Re: PA23-012 – English Crossing Townhomes – Technical Review 1

RE: English Crossing, File# PA23-012
247 New Townhomes
17406 19th Ave NE & Parcel # 31051900401200

To: Merle Ash, Land Technologies
From: Don McGhee, Assistant Fire Marshal
Date: June 1, 2023
Subject: PA23-012 English Crossing Townhomes 17406 19th Avenue NE

SUBJECT: PA23-012 English Crossing, April 2023 TIA & Technical Review #1

Figure 1. Tall retaining walls must be terraced with landscaping as depicted below.

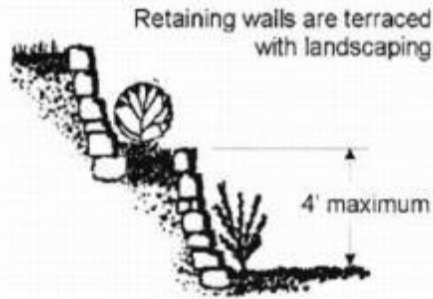
6. For units that do not provide the required three parking stalls at the unit, please demonstrate that those stalls not adjacent to the unit are within 100 feet, as required by [MMC 22C.130.020\(5\)\(b\)](#).
7. Pursuant to [MMC 22D.050.030\(4\)\(e\)](#), if retaining walls taller than four feet are used, and are visible from the street or adjacent property, they shall be terraced so that no individual segment is taller than four feet. On page 3 of the project narrative, it states that a 6' retaining wall will be placed along the back of the landscape buffer for buildings along 19th Avenue. Walls over 6 feet in height are required to be terraced, as depicted below.
